GARD response to

Ofwat's Consultation on Draft Ofwat Gate 2 Decision

Volume 1 – Main report and appendices

GARD Review of Draft Ofwat Gate 2 Decisions

Figure F4 - Central Region planned PCC reduction and household meter penetration

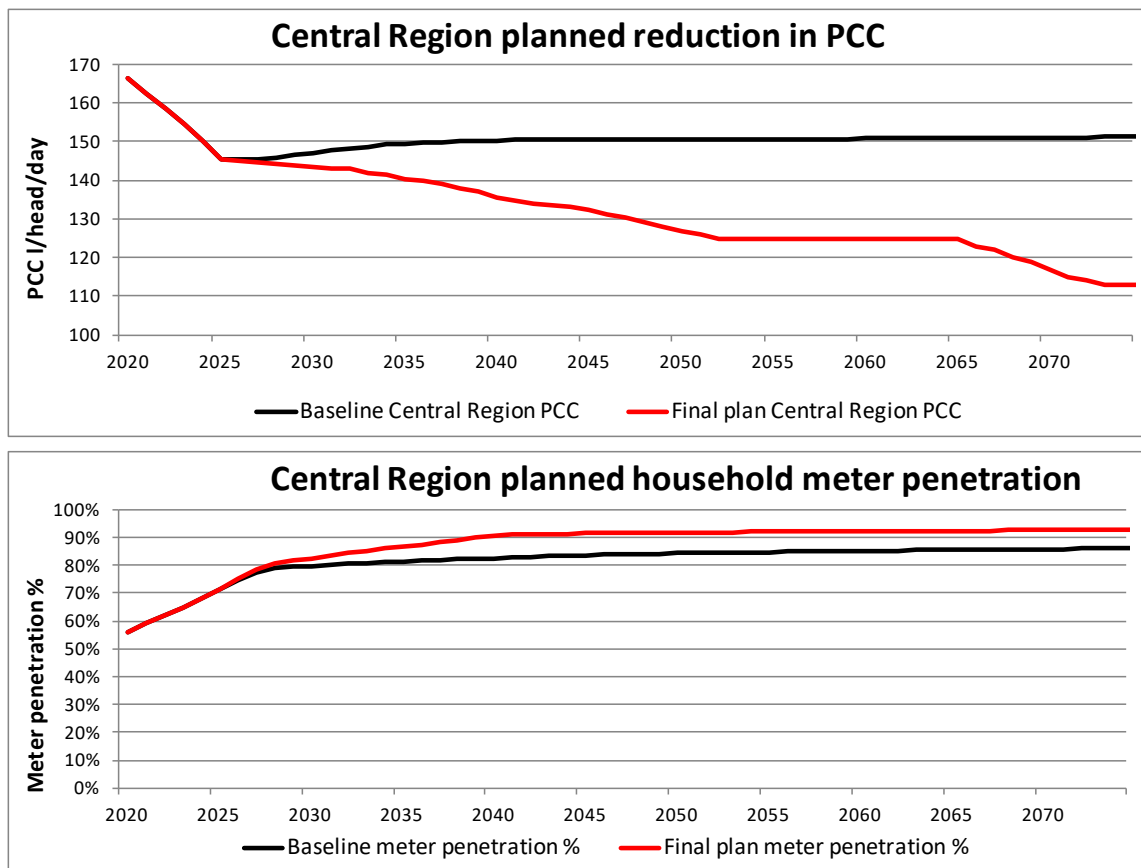
Figure F4 shows that Affinity Water plan eventually to get close to the Government's 110 l/h/d target, reaching 113 l/h/day by 2075. However, by 2040, the planned PCC of 135 l/h/d is well above the Government target.

Figure K1 - Cross-section of reservoir showing borrow pit

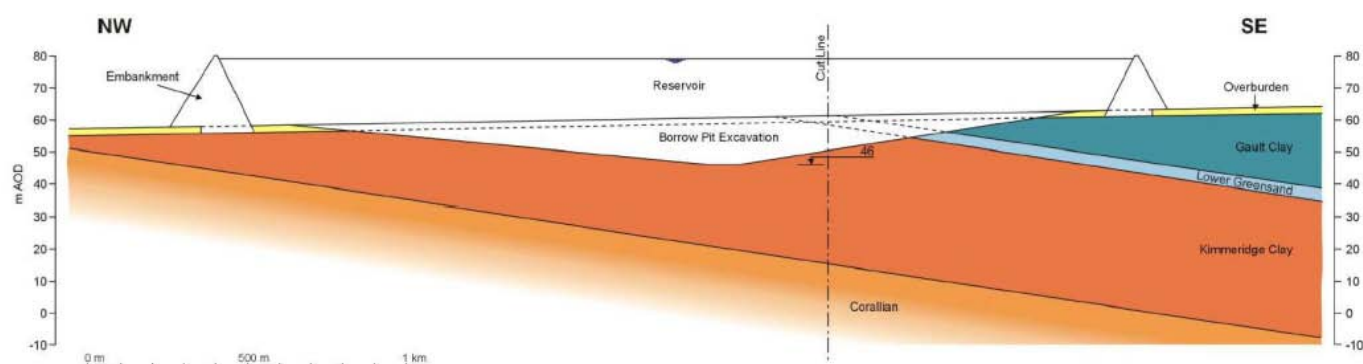
Therefore there should be a minimum average depth of 5m of water when the emergency storage is empty. Figure 21 shows a cross-section of the reservoir and borrow pit¹⁹¹:
